CONSTRUCTION OF NEW MUNICIPAL SOFTBALL PARK REBID

PROJECT NO.: 08-18-C28-608

A D D E N D U M NO. 1

ADDENDUM No 1
SOFTBALL FIELD FACILITIES
MUNICIPAL PARK
McALLEN, TEXAS

WALL SECTION 1
SCALE: 1" = 1'-0"

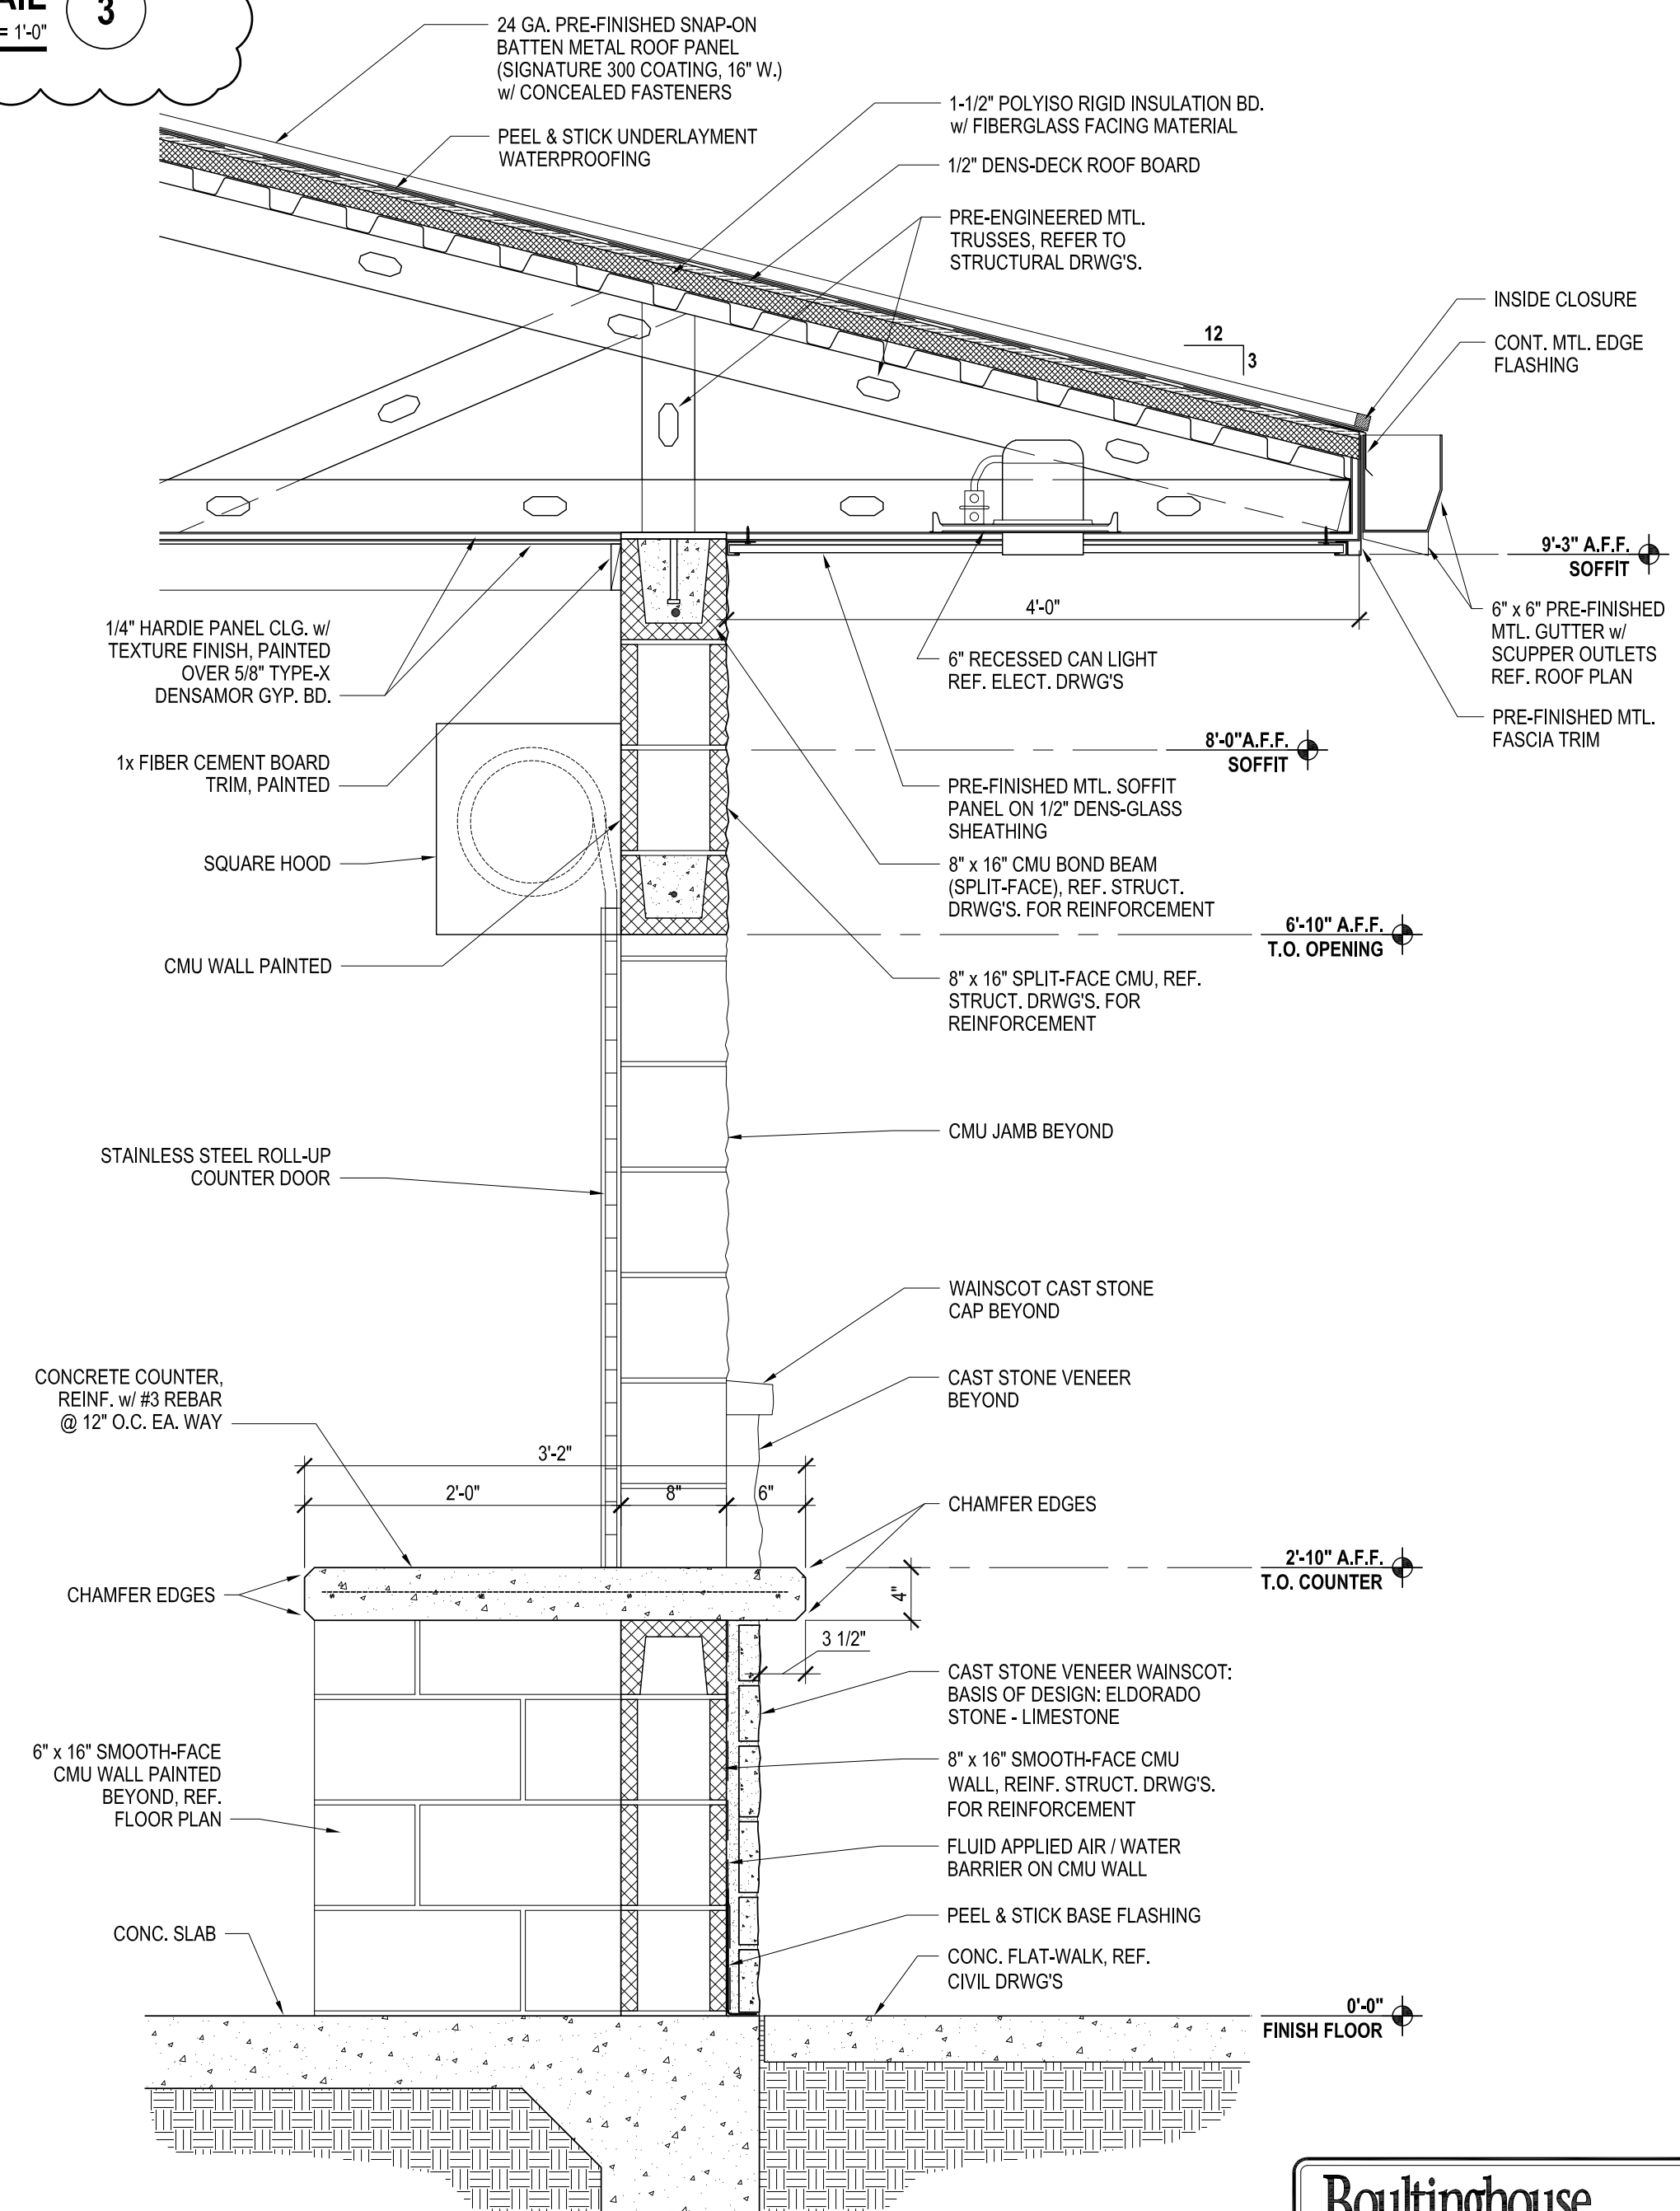
- A2.1 Added outline of Cupola wall above. Added RCP key note #7 & revised key note #8.
- A2.2 Relocated ADA urinal, added ADA notes & dimensions.
- A2.3 Relocated ADA urinal, added ADA notes & dimensions.
- A3.1 Added Cupola & material call outs.
- A4.1 Added wall section at Cupola. Added ADA notes & dimensions.
- A4.2 Added wall detail at Cupola.

Project No.:	33348
Issued:	07-11-18
Drawn By:	K.G.J.B
Checked By:	H.A.
Scale:	AS NOTED
Sheet Title	MECHANICAL PLAN
Sheet Number	M1.01

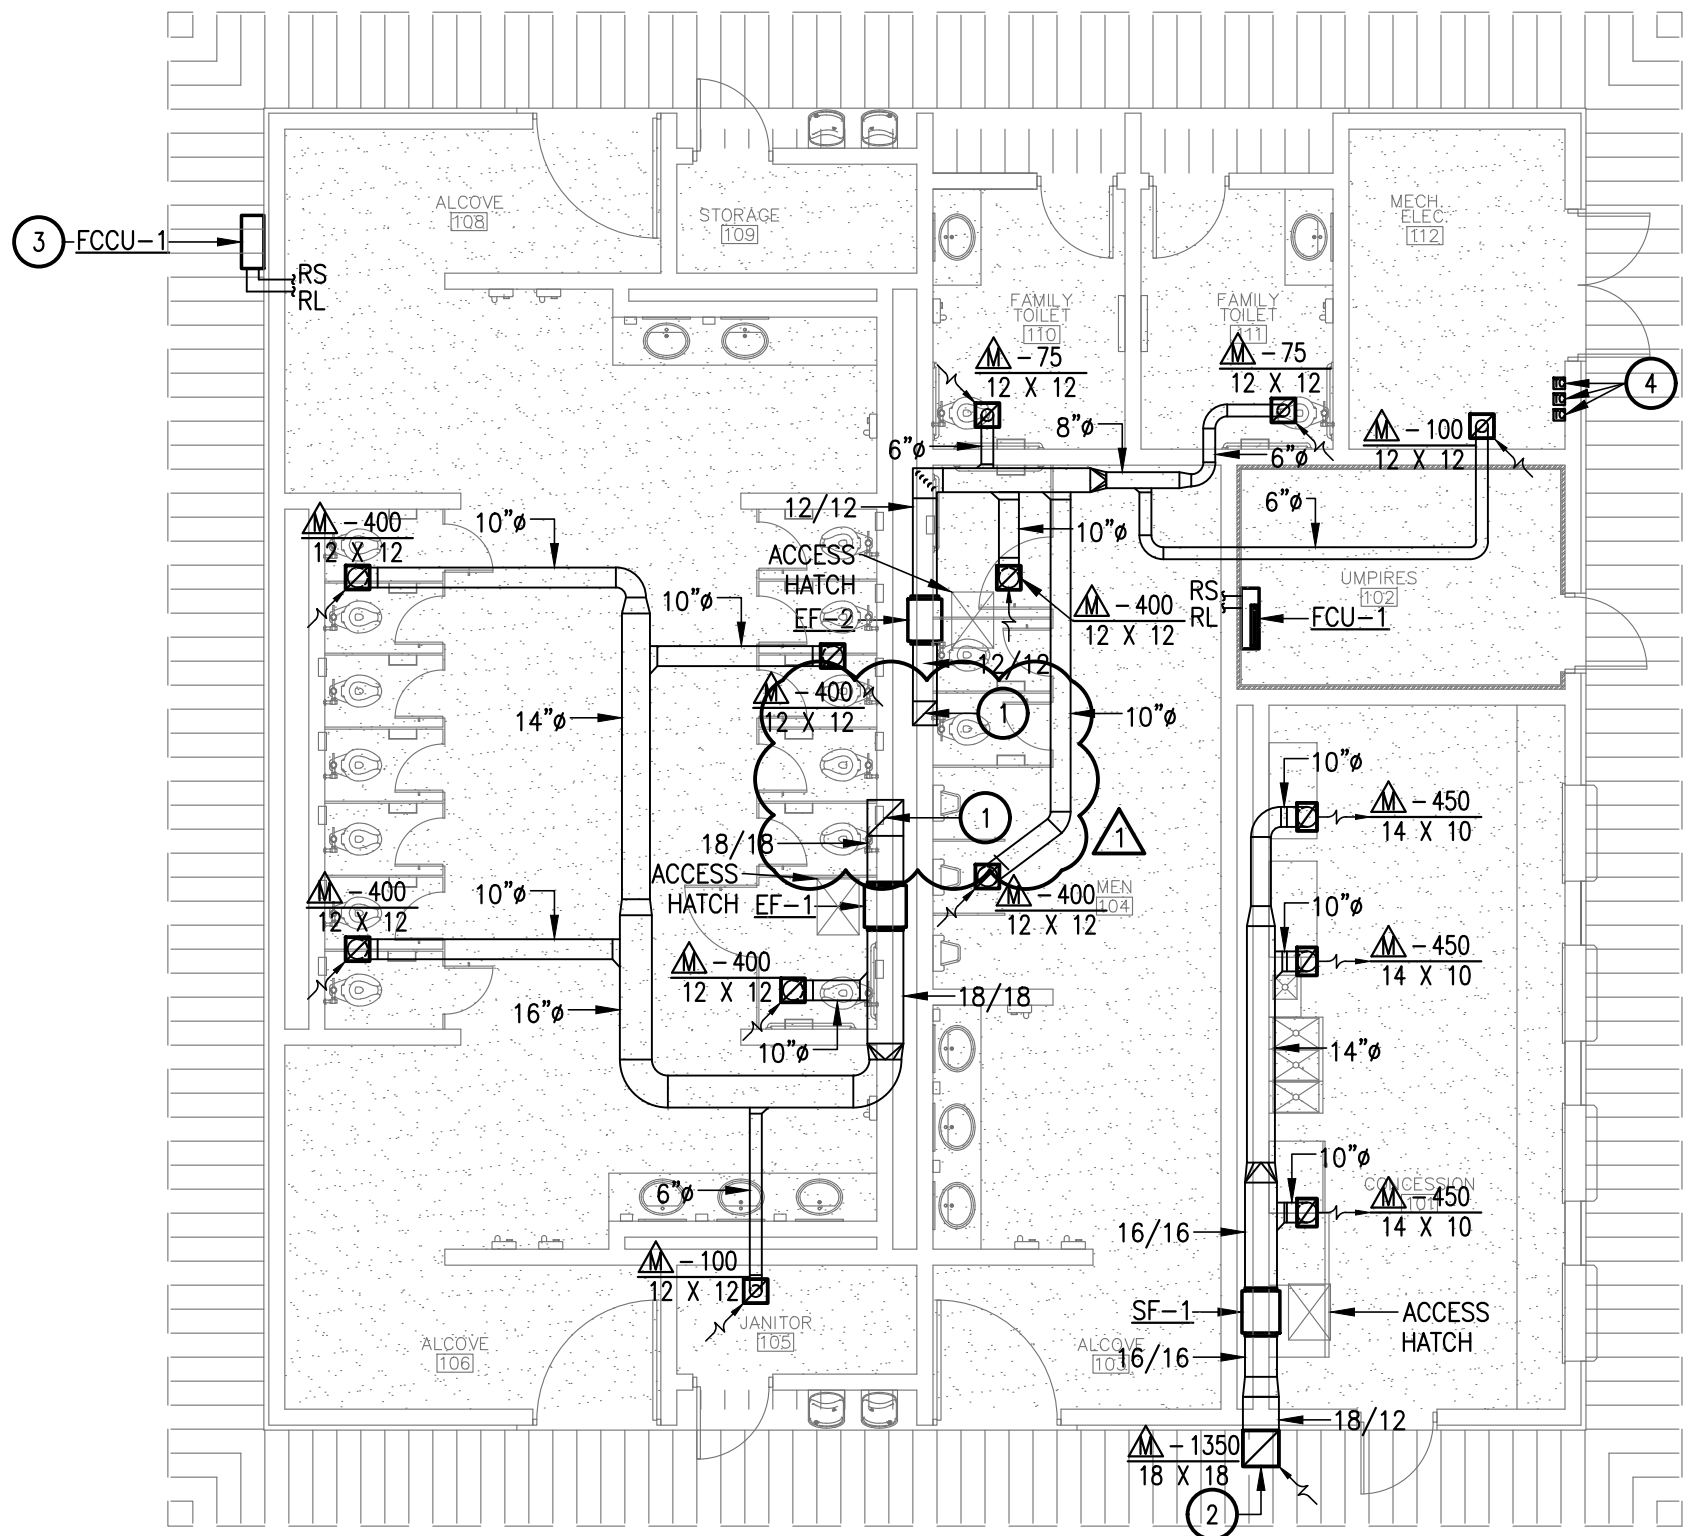
- ITEM 1. Modification: Sheet M1.01, to Keyed Note 1. Modified verbiage to reflect cupola addition.
- ITEM 2. Modification: Sheet M1.01, to Mechanical Plan. Removed relief hoods and re-route ductwork.
- ITEM 3. Removal: Sheet M2.01, Relief Hood Schedule. Relief Hood Schedule has been deleted. Schedule no longer applies

Project No.:	33348
Issued:	07-11-18
Drawn By:	CHAVEZ/MG
Checked By:	TED
Scale:	AS NOTED
Sheet Title	CONCESSION BUILDING ELECTRICAL PLANS
E1.04	
Sheet Number

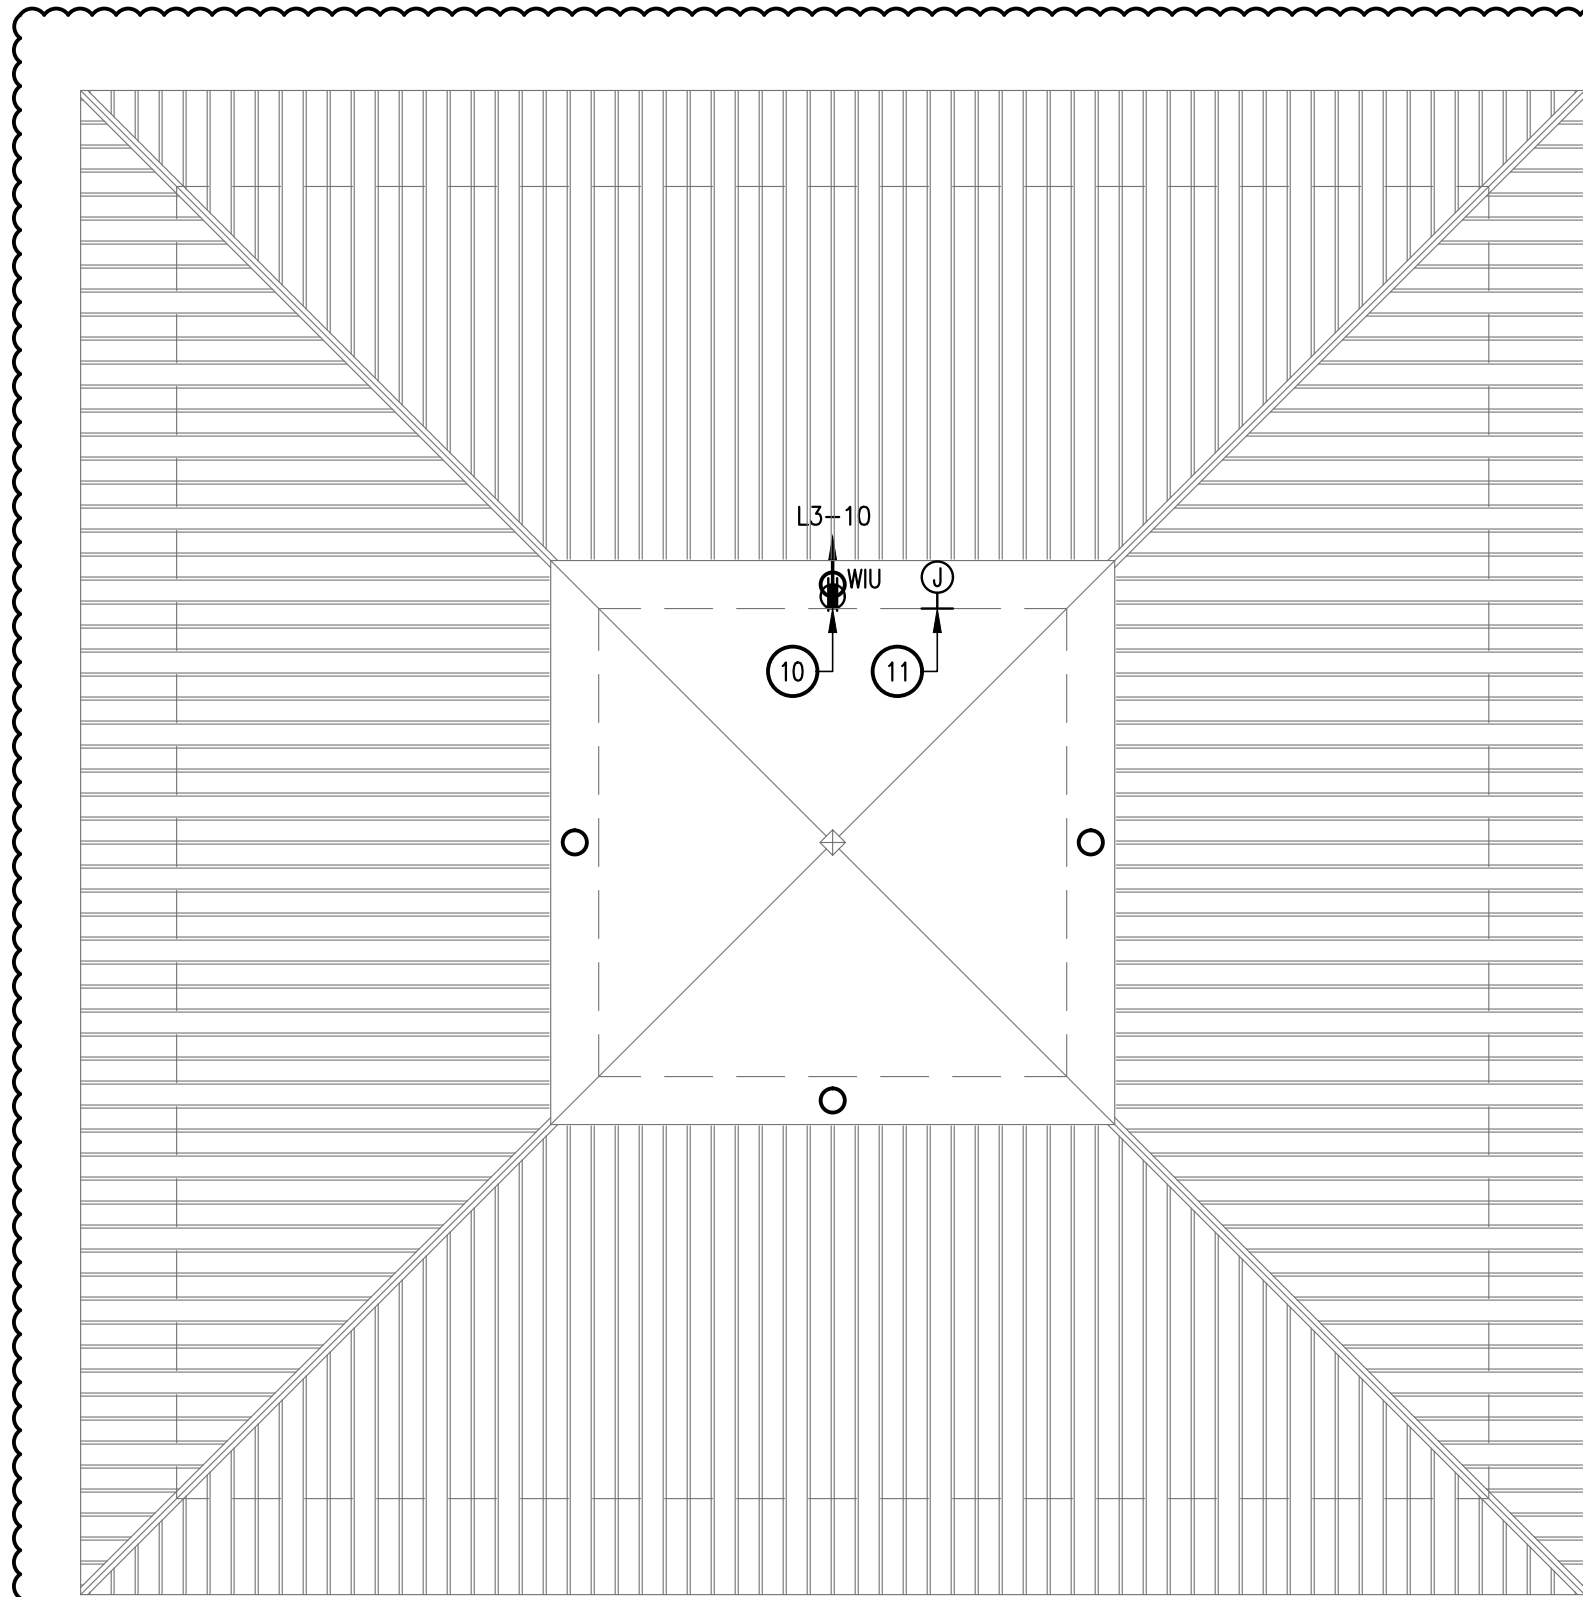
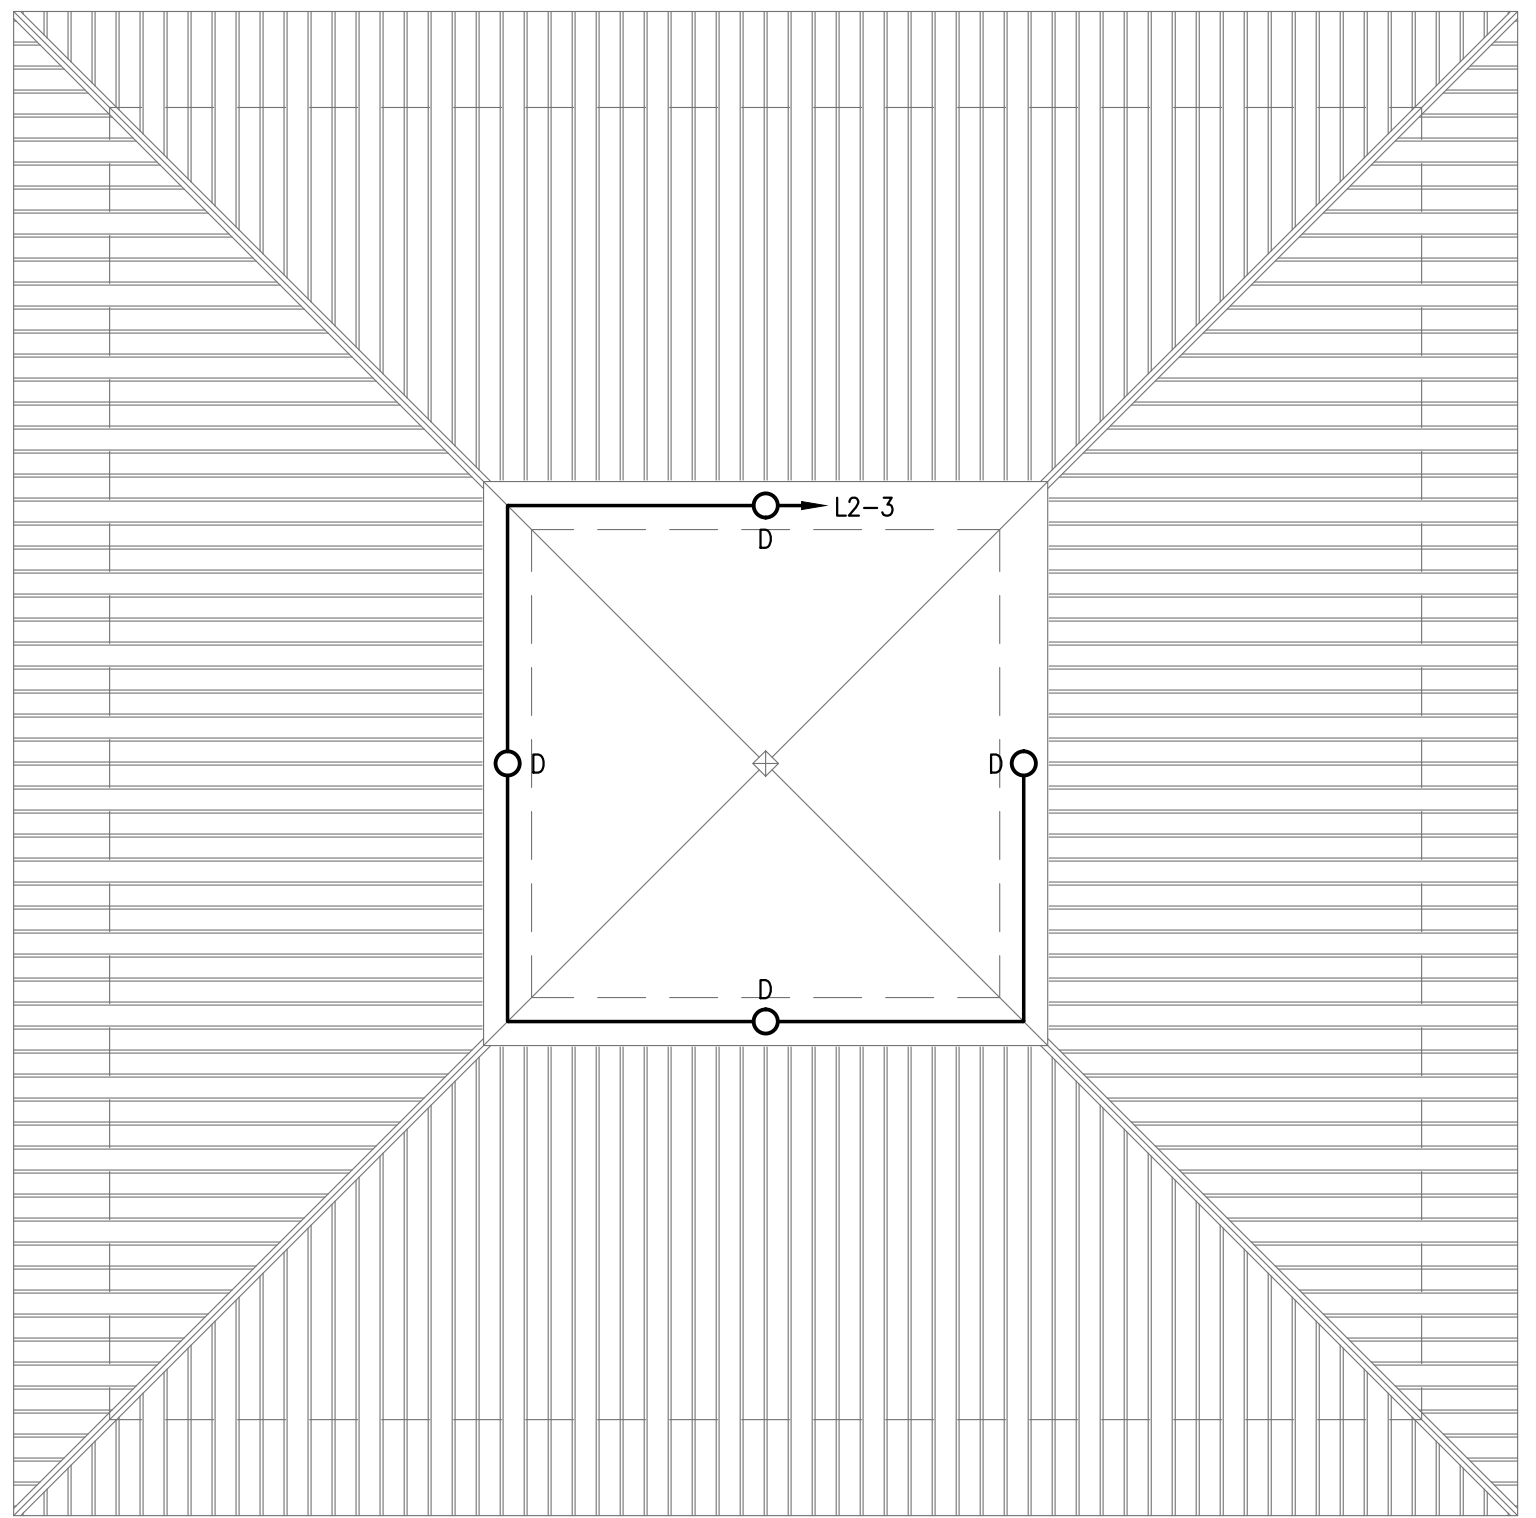
- ITEM 1. Addition: Sheet E1.04, added cupola plans for lighting and power. Added Keyed Notes #10 and #11.
- ITEM 2. Modification: Sheet E3.04, modified panel schedule 'L3' to reflect electrical circuit to outlet at cupola.
